PLANS AND DOCUMENTS
referred to in the REFERRAL
AGENCY RESPONSE

SARA ref: 2512-49704 SRA

Amended in red by SARA on
7 May 2026

Stormwater Management Plan
Proposed Refurbishment of Lions Richlands Club at 133 Pine Road, Richlands
For Lions Richlands

Figure 3.1. Existing and Proposed Stormwater Layout Sketch

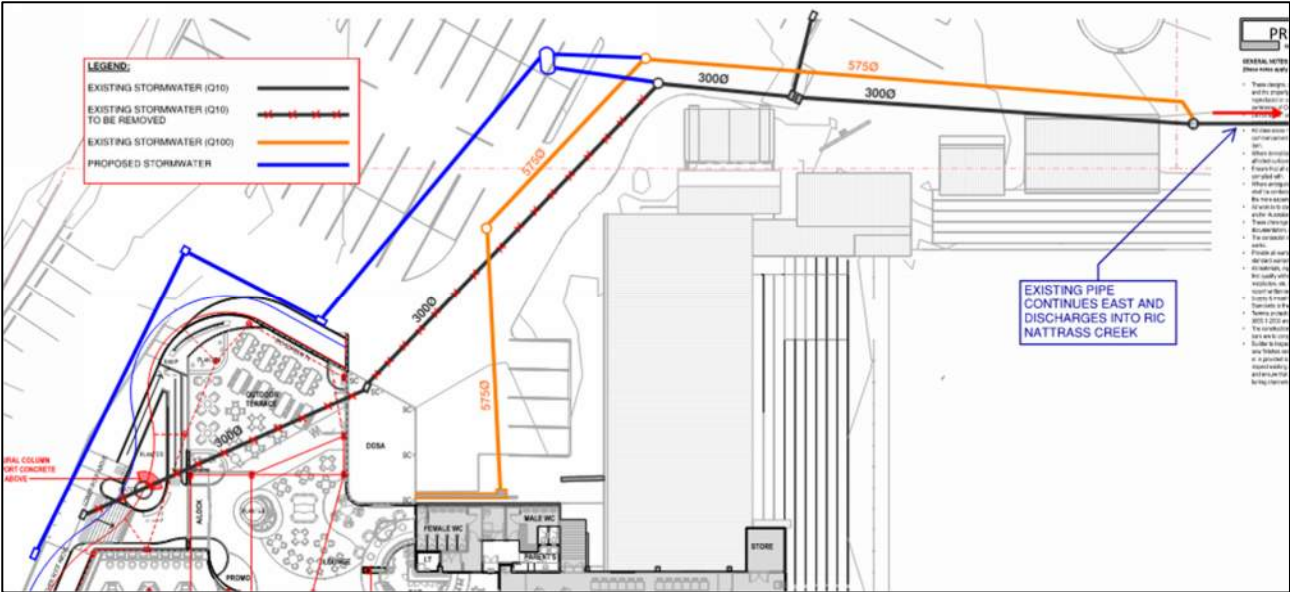
~~3.2 Previous Carpark Drainage Upgrades~~

~~The existing internal drainage system functions based on standard minor and major drainage principles in accordance with QUDM. For clarity, Lambert & Rehbein were engaged in 2021 to investigate overland flow issues within the loading bay area. The site currently contains two drainage lines: the original pipeline (300mm dia.) servicing minor storm events (10% AEP), and a second drainage line (525mm dia.) subsequently constructed through the downstream portion of the carpark to convey major storm flows (100% AEP) to address the overland flow issues. The major drainage line extends through the northeast of the site and reconnects with the existing pipeline at the end of the carpark, where flows discharge to Ric Natrass Creek. Any surcharge flows from this location ultimately reach the creek via surface flow.~~
